# **ASSESSMENT REPORT**

## **Generic Design Assessment: Disposability Assessment for Wastes and Spent Fuel arising from Operation of the UK ABWR Part 1: Main Report**

Document information	
RWM Document Number:	LL/23788023
Date:	November 2016

**This document has been produced by Radioactive Waste Management Limited to advise on waste transport and disposability issues in response to a waste conditioning proposal submitted by Hitachi-GE. The assessment basis adopted by Radioactive Waste Management Limited assumes waste packaging and on site storage for an interim period, transport to an off-site Geological Disposal Facility, emplacement of waste packages underground in a monitored and retrievable form followed by eventual sealing and closure of the facility.**

**Figure 4 Illustration of an ABWR control rod, from [18]**

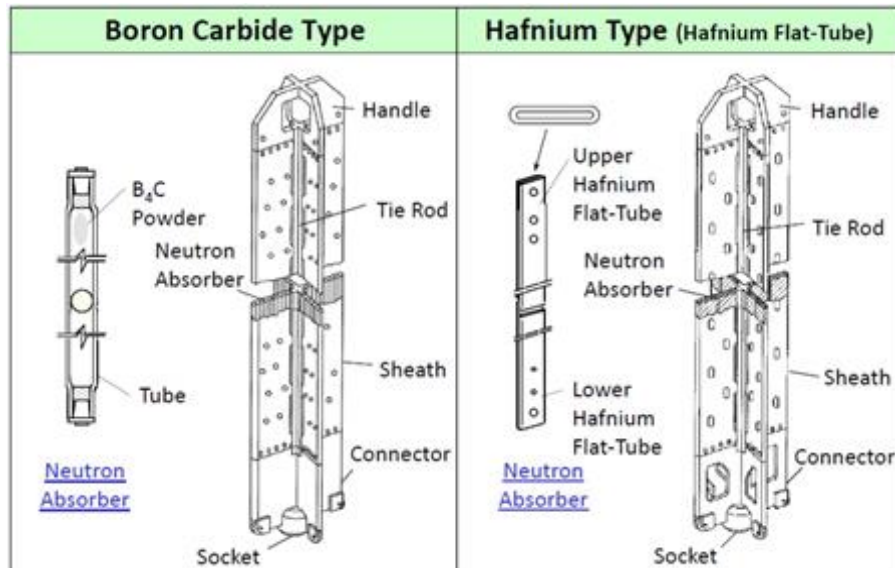
The control rods may have to be cut prior to packaging, and future interactions under the Disposability Assessment process will need to consider how control rods are cut without release of the boron carbide powder. To fit into  $3\text{m}^3$  boxes, Control Rods would have to be cut into at least four pieces. Diagrams of the control rods suggest that the rods are sectioned so that cuts could be made through sections of stainless steel not containing any  $\text{B}_4\text{C}$  powder (Figure 4). However, accidental releases of boron carbide powder could still be possible and the operator of a UK ABWR should have a contingency plan in place in case this should happen and the affected rods cannot be grouted. Evidence that control rods can be cut up is available from PWRs.

**Figure 5 Illustration of a  $3\text{m}^3$  Box (left) and a  $3\text{m}^3$  Drum (right) as proposed for packaging of operational and decommissioning ILW from a UK ABWR**

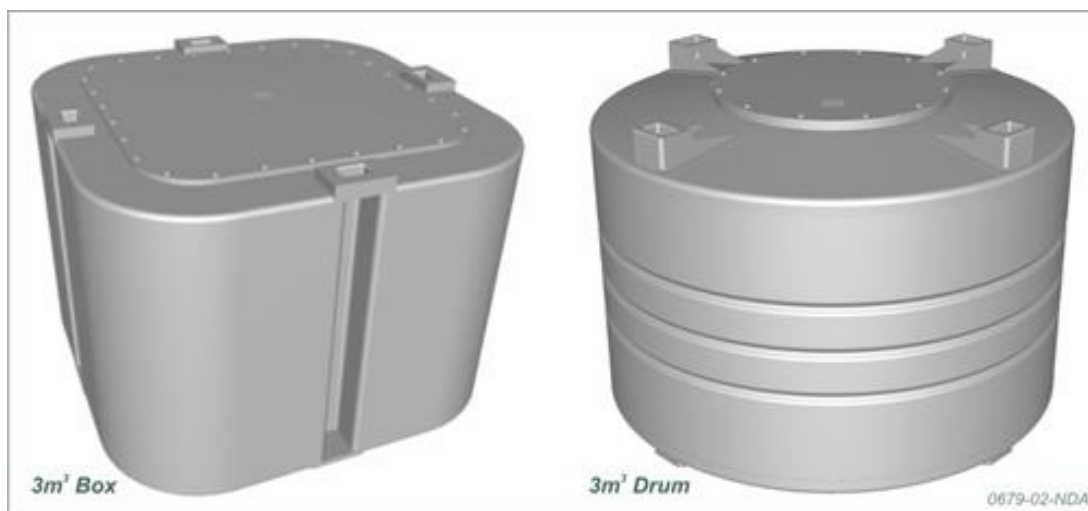
The package numbers assume that approximately 40 control rods would be packaged in each  $3\text{m}^3$  Box. This packing density is considered to be high (a value closer to 12-15 control rods per package may be more realistic), and should be reconsidered at later stages of assessment in the future through the Disposability Assessment process. The number of Mixed Metal ILW packages is based on a packing density of 7.58t of raw waste per package. This packing density is considered unlikely to be feasible on volume grounds and should be reassessed in future interactions under the Disposability Assessment process. The  $3\text{m}^3$  Boxes would need to be transported in an SWTC-285 to meet the 2012 IAEA Transport Regulation dose rate requirements [22]. Both the  $3\text{m}^3$  Drum and  $3\text{m}^3$  Box are standard RWM waste containers and are illustrated in Figure 5.

Hitachi-GE's original proposals for packaging this waste stream were to utilise 4-metre Boxes. However, preliminary analysis of this packaging proposal by RWM demonstrated that it would not be possible to meet the 1m dose rate limit contained in the 2012 IAEA Transport Regulations [22] for any credible cooling period following reactor shutdown. Therefore, following discussion between RWM and Hitachi-GE, the proposed packaging assumption for Reactor Pressure Vessel Internals was modified to be for grout encapsulation in 3m<sup>3</sup> Boxes transported in an SWTC-285. Such an arrangement provides a much enhanced level of gamma shielding compared to packaging in a 4-metre Box and transporting as an IP-2 package.
